# Agenda of The Technical Meeting (Third Day)

# Agenda of The Technical Meeting (Fourth Day)

# Agenda of The Technical Meeting (Fifth Day)

Agenda of The Technical Meeting (First Day)

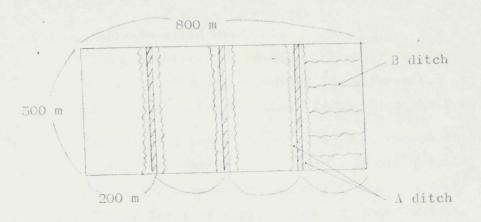
\* System of Agricultural Operation In addition to JISDECO's plan of cane cultivation the drainage ditches inside unit field (500 m x 800 m) as shown below are considered necessary for full growth of cane:

According to the discussion between Mr. Adnan and Mr. Yamashita on 13th, Dec., 1965, the afore mentioned drainage ditches shall be executed in the Ratooning fields as well as the first planting field.
